SUBDIVISION REVIEW SHEET

CASE NO: C8-2011-0061.0A

SUBDIVISION NAME: Resubdivision of Jetco Partners International Resubdivision #1

MEMORANDUM

RESUBDIVISION OF JETCO PARTNERS INTERNATIONAL RESUBDIVISION ONE

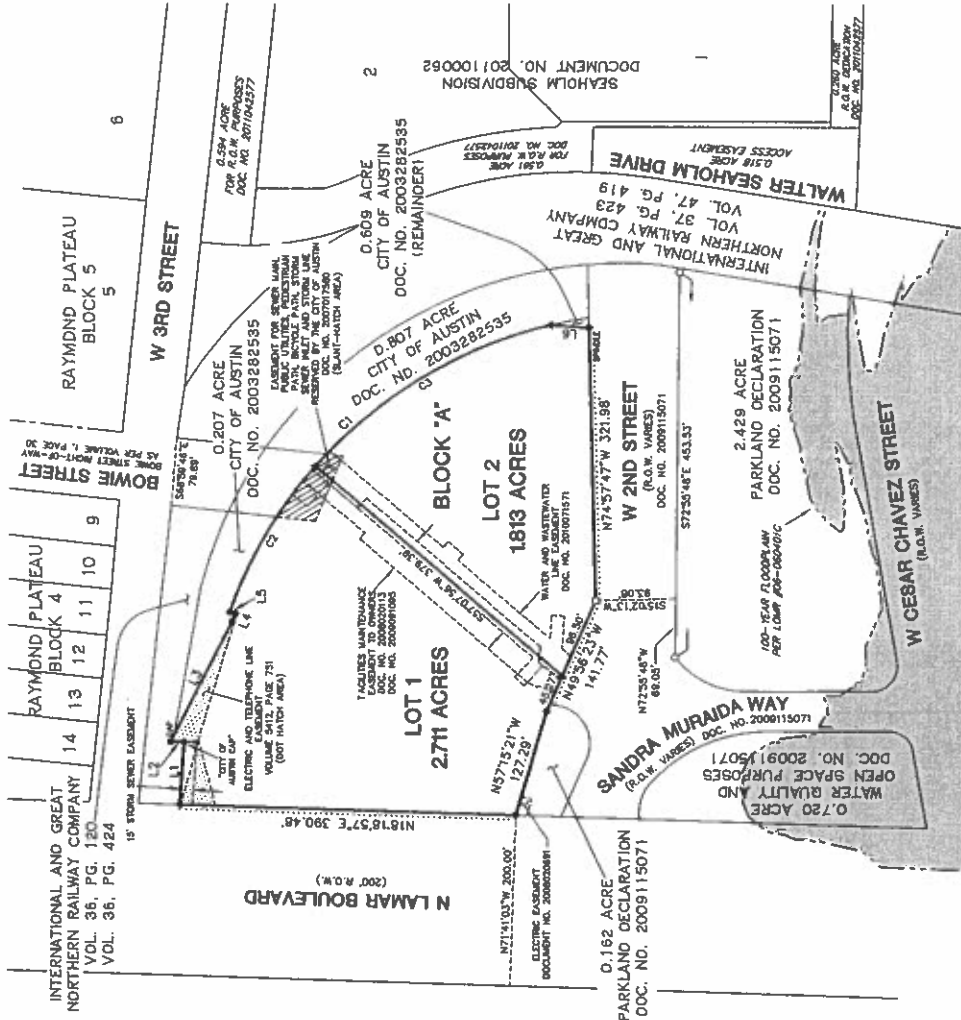
VARIANCES: The applicant requests a variance from LDC Section 25-4-151 which requires streets in new subdivisions connect to streets in adjacent subdivisions. The applicant proposes to not connect Bowie Street. (Recommended.) See attached memorandum from transportation review.

The applicant for the above referenced subdivision is requesting a variance to Title 25 of the Land Development Code (LDC) Section 25-4-151, which requires streets of new subdivisions must be in line with existing streets in adjoining property except where the Comprehensive Plan, topography, requirements of traffic circulation or other considerations make it desirable to depart from such alignment. The variance requested is for Bowie Street.

The subject property is located at 115 Sandra Muraida Way. There is an active site plan on this property called 'Gables at Park Plaza'. Bowie Street is an existing street that dead ends at the railroad tracks on the north end of the property.

Staff recommends approval of the variance for the following reasons:

- Due to existing UP railroad tracks, it is not feasible to extend Bowie Street through the subdivision.
- No existing or proposed lots would be landlocked if Bowie Street is not extended.
- Traffic circulation in the subdivision would not be compromised if Bowie Street is not extended.
